INDESIT company

Model type:
IDV75UK

Commercial code:
F074628

07475-05 Exploded views

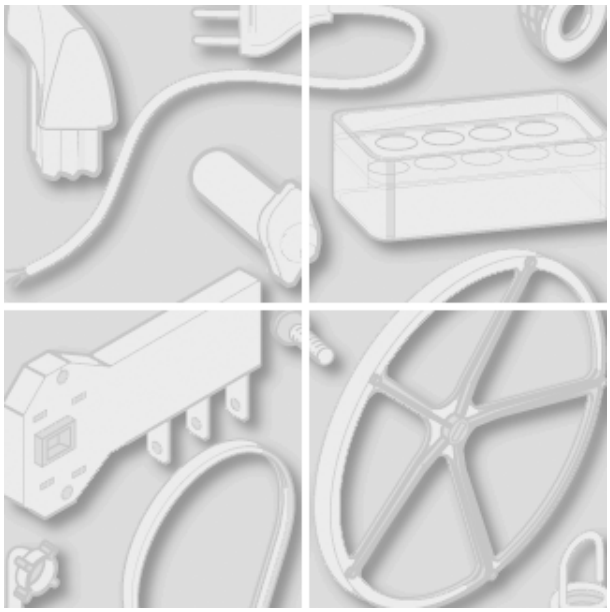
n4412k00: ALTERNATIVE INDESIT VENTED TIMERS/CONSOLE CHANGES

DUE TO PRODUCTION SHORTAGES FROM SERIAL NUMBER 20730.0000 (JULY 30 2012) TO SERIAL NUMBER 21015.0000 (OCT 15 2012) A BITRON ELBI TIMER (16002841700) AND ASSOCIATED CONSOLE AND TIMER KNOB HAS ALSO BEEN USED IN PRODUCTION.
THIS ELBI TIMER (16002841700) IS NOT INTERCHANGEABLE WITH THE PRODUCTION TIMERS.
THESE MACHINES CAN BE IDENTIFIED BY 16002841700 STAMPED ON THE TIMER AND THE CONSOLE MARKED TO 140 MINUTES
NORMAL PRODUCTION CONSOLES ARE MARKED TO 120 MINUTES DURING THIS PERIOD.

IN A PHASED INTRODUCTION STARTING NOVEMBER 2012 "B" ENERGY CONSOLE ASTHETHICS MARKED TO 140 MINUTES HAVE BEEN USED IN PRODUCTION.

07475-15 Exploded views

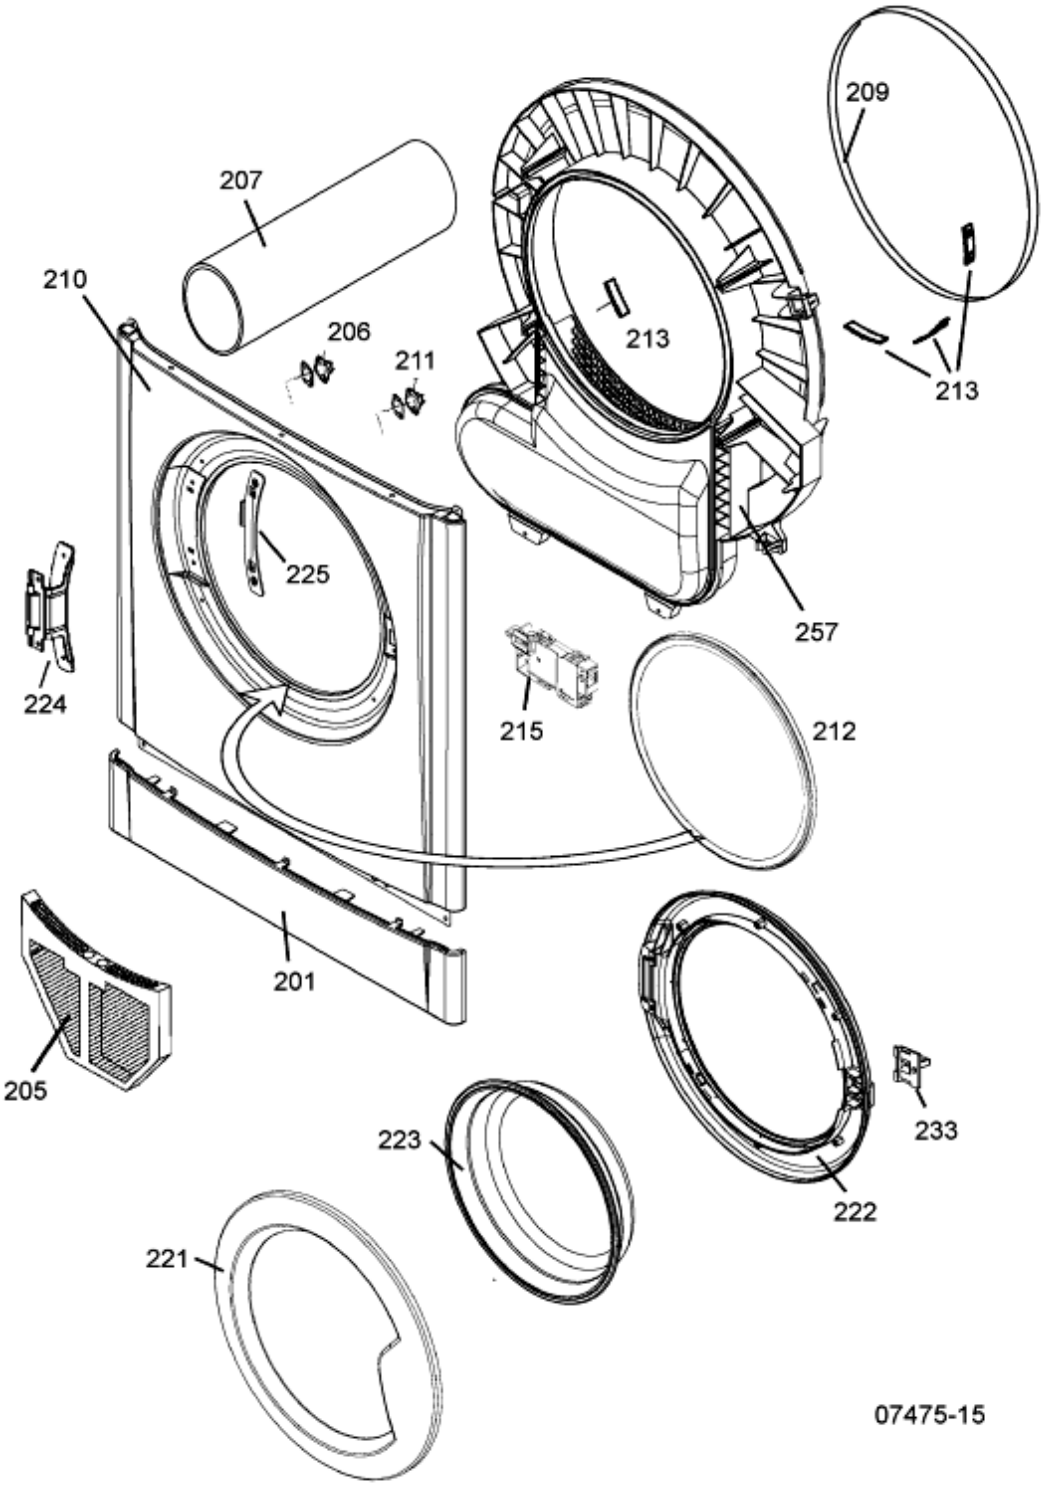
n4411g04: COLOUR CHANGE TO THE FILTER> VENTED DRYERS

FROM JUNE 2011 THE FLUFF FILTER FITTED TO VENTED TUMBLE DRYERS CHANGED IN PRODUCTION FROM GREY TO WHITE.
SELECTED THE CORRECT PART BY DESCRIPTION IN THE PARTS LIST

n4414c02: VENTED AIR DUCT

FROM JUNE 2011 THE FRONT AIR DUCT FITTED TO VENTED TUMBLE DRYERS CHANGED IN PRODUCTION FROM GREY TO WHITE.
ONCE STOCK OF THE GREY AIR DUCT IS EXHAUSTED, ONLY THE WHITE WILL BE THE SERVICE SPARE.

A NEW VENTED AIR DUCT, FILTER AND DRUM FRONT SEAL WERE USED IN PRODUCTION BETWEEN 7th OCTOBER AND 16th OCTOBER 2013 (sn 31007.0000 to sn 31016.9999)
DURING THESE DATES WHEN REQUIRING AN AIR DUCT, FILTER OR DRUM FRONT SEAL, PLEASE ORDER ALL 3 PARTS FROM THE PARTS LIST AND REPLACE ALL 3 PARTS.
FOR ALL OTHER DATES ONLY THE PART WANTED WILL BE REQUIRED..

n4414f02: VENTED AIR DUCT-FILTER-FRONT SEAL

FROM JUNE 2011 THE FRONT AIR DUCT FITTED TO VENTED TUMBLE DRYERS CHANGED IN PRODUCTION FROM GREY TO WHITE.
ONCE STOCK OF THE GREY AIR DUCT IS EXHAUSTED, ONLY THE WHITE WILL BE THE SERVICE SPARE.

FROM JUNE 2014 IN A PHASED INTRODUCTION A NEW VENTED AIR DUCT, FILTER AND DRUM FRONT SEAL HAVE BEEN USED IN PRODUCTION.
THESE NEW PARTS ARE NOT INTERCHANGEABLE. SEE PARTS LIST

THE NEW AIR DUCT-FILTER-FRONT AXIAL SEAL WERE ALSO USED IN PRODUCTION BETWEEN 7th OCTOBER AND 16th OCTOBER 2013 (sn 31007.0000 to sn 31016.9999) ON THE MODELS LISTED BELOW.

07475-20 Exploded views

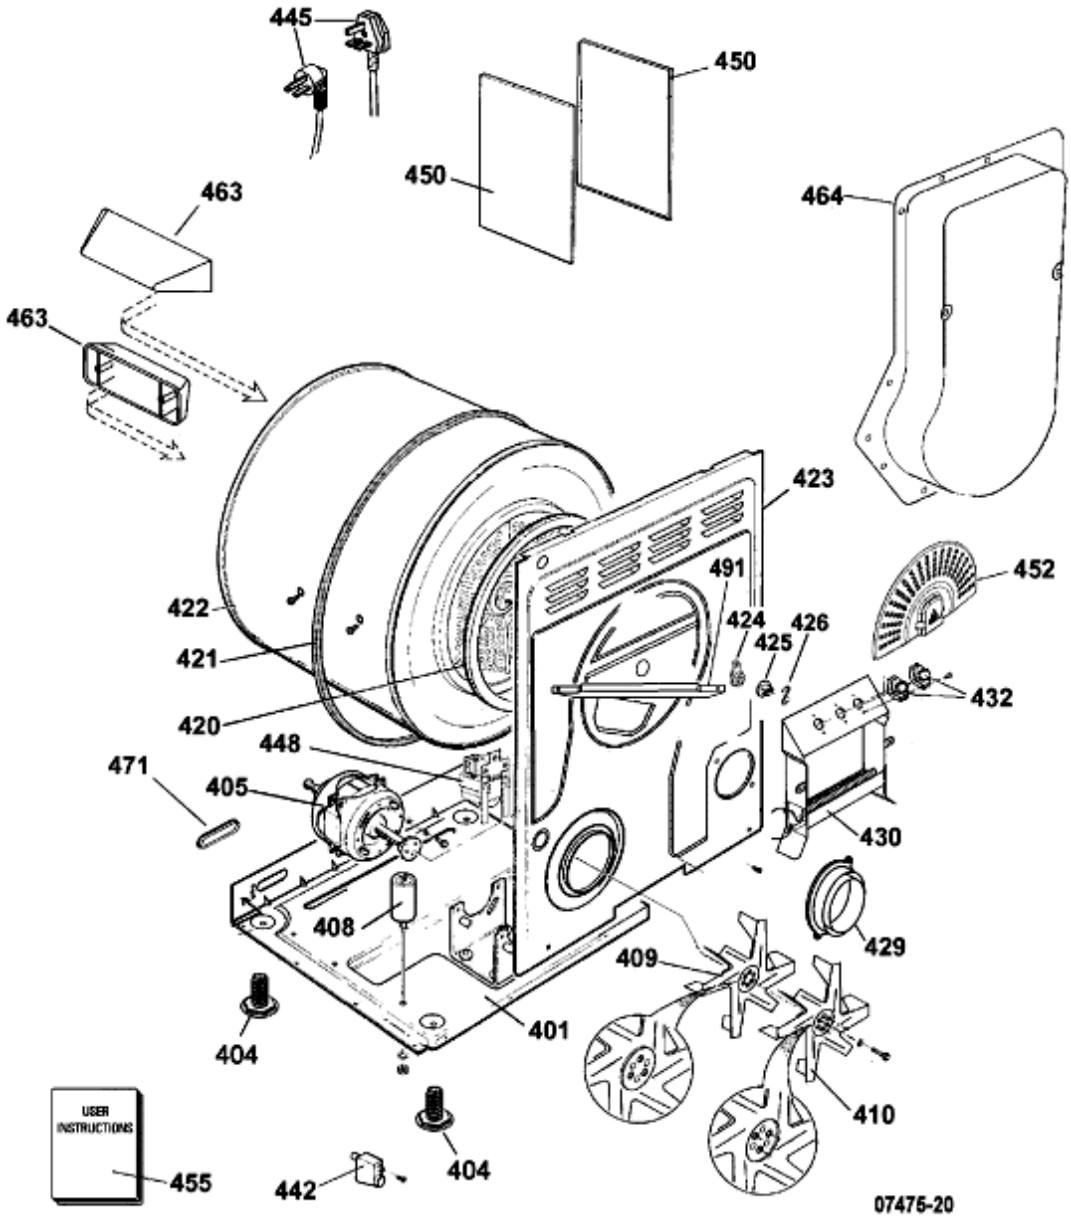
n4408a01: VENTED TUMBLE DRYER HEATERS

From Serial Number 70802.0001, Two different Heater manufacturers were used in production. These DBK and Blaissi Heaters are totally interchangeable if replaced as an assembly.

But the thermostat kits for these Heaters are not interchangeable.

From Serial number 70802.0001, before a Stat. Kit is replaced the heater fitted to the machine must be identified first.
The cover of the Blaissi heater has 2 raised dome shaped pips, there is also a Blaissi Label inside the heater attached to the inside of the heater cover
The Cover of the DBK Heater has 4 raised dome shaped pips.

DBK heaters and covers are used as service spares, therefore if a heater or cover have previously been replaced further identification is required.

The DBK heater element wire is in a strip.
The Blasi heater element wire is circular.

For the Dryer to work correctly the correct Heater and Stat. Kit must always be fitted.

n4409g00: VENTED MOTOR CHANGE

Two "368" Motors have been used in production. ANA IMEP and Welling.
These motos are interchangable providing the correct capacitor/motor combination is used.
The 358 motor is used on 7kg models and will replace the 368 motor in production on 6kg models during 2011. The type fitted can be identified from the motor rating label.
THE 358 MOTOR CAN BE USED TO REPLACE THE 368 MOTOR PROVIDING THE CORRECT CAPACITOR IS USED.
THE 368 MOTOR MUST NOT BE USED TO REPLACE THE 358 MOTOR.
ONCE SUPPLIES OF THE 368 MOTOR ARE EXHAUSTED, THE 358 MOTOR WILL BECOME THE SERVICE SPARE.
CAPACITORS
If a Capacitor is required the motor Type must be confirmed first.

ANA IMEP 368 Vented Motors use only a 7uf Capacitor
Welling 368 and both 358 Vented Motors use a 9uf capacitor
THE CORRECT CAPACITOR MUST ALWAYS BE FITTED.

n4412c01: VENTED TUMBLE DRYER DRUM LIFTER

From Sept 2011, a curved drum lifter, has been used in production, the new lifter is fully interchangeable with the original straight drum lifter, once stock of the straight drum lifter is exhausted, the curved drum lifter will become the Service Spare, for all production dates".

n4412l05: MOTORS. VENTED MECHANICAL TIMER DRYERS

SEVERAL DIFFERENT MOTORS HAVE BEEN USED DURING PRODUCTION
THE SERVICE MOTOR KIT (358 MOTOR AND 9uF CAPACITOR) IS A DIRECT REPLACEMENT PROVING BOTH THE MOTOR AND CAPACITOR ARE REPLACED.
